NRC 2018-0038
10 CFR 50.90

Point Beach Nuclear Plant, Units 1 and 2
Dockets 50-266 and 50-301

Subject: Response to Request for Additional Information Regarding License Amendment Request 287, Application to Adopt 10 CFR 50.69, "Risk informed Categorization and Treatment of Structures, System, and Components (SSCs) for Nuclear Power Plants"

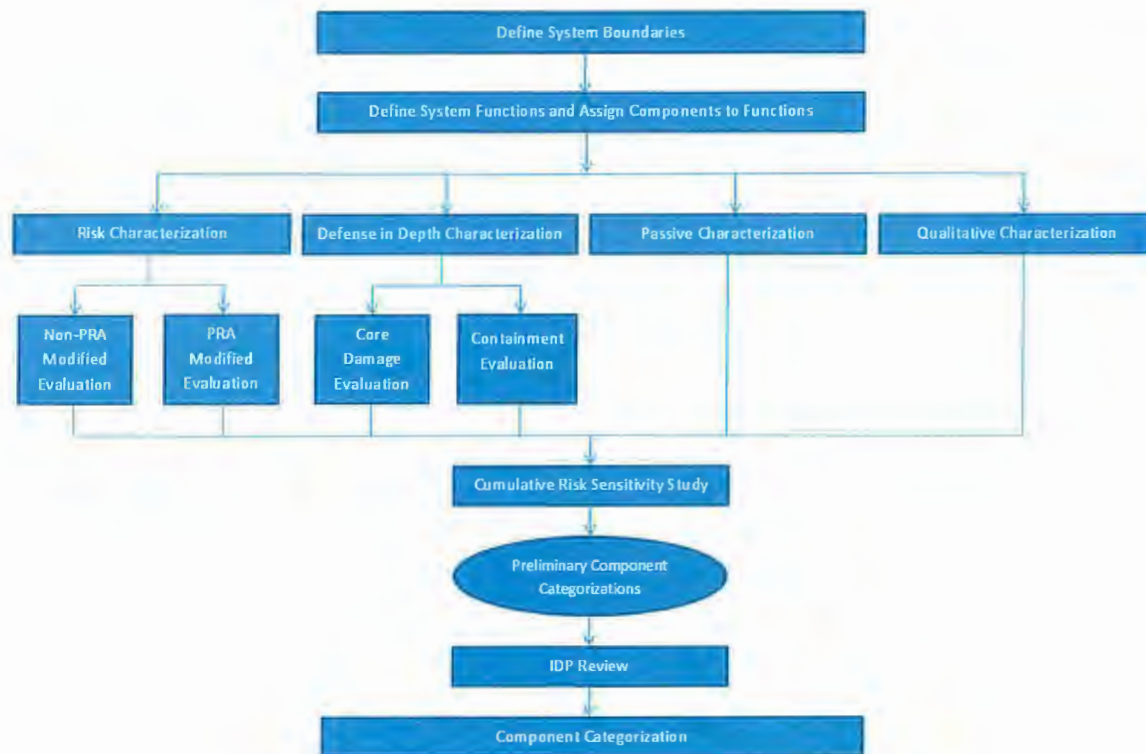
- a. Summarize, in the order they will be performed, the sequence of elements or steps that will be followed to categorize a respective system. A flow chart, such as that provided in the NEI presentation (ADAMS Accession Number ML17249A072) for the September 6, 2017, public meeting with NEI regarding 10 CFR 50.69 LARs (ADAMS Accession Number ML17265A020) may be provided instead of a description. The steps should include:
 - i. The input from all PRA evaluations such as use of the results from the internal events, internal flooding, seismic, and fire PRAs;
 - ii. The input from non-PRA approaches (other external events, and shutdown);
 - iii. The input from the responses to the seven qualitative questions in NEI 00-04, Section 9.2;
 - iv. The input from the defense-in-depth (DID) matrix;
 - v. The input from the passive categorization methodology.

- a-c. The process to categorize each system will be consistent with the guidance in NEI 00-04, “10 CFR 50.69 SSC Categorization Guideline,” as endorsed by RG 1.201. RG 1.201 states that “the implementation of all processes described in NEI 00-04 (i.e., Sections 2 through 12) is integral to providing reasonable confidence” and that “all aspects of NEI 00-04 must be followed to achieve reasonable confidence in the evaluations required by §50.69(c)(1)(iv).” However, neither RG 1.201 nor NEI 00-04 prescribe a particular sequence or order for each of the elements to be completed. Therefore, the order in which each of the elements of the categorization process (listed below) is completed is flexible and as long as they are all completed; they may even be performed in parallel. Note that NEI 00-04 only requires Item 3 to be completed for components/functions categorized as LSS by all other elements. Similarly, NEI 00-04 only requires Item 4 to be completed for safety related active components/functions categorized as LSS by all other elements.

On the following page is an example of the major steps of the categorization process described in NEI 00-04.
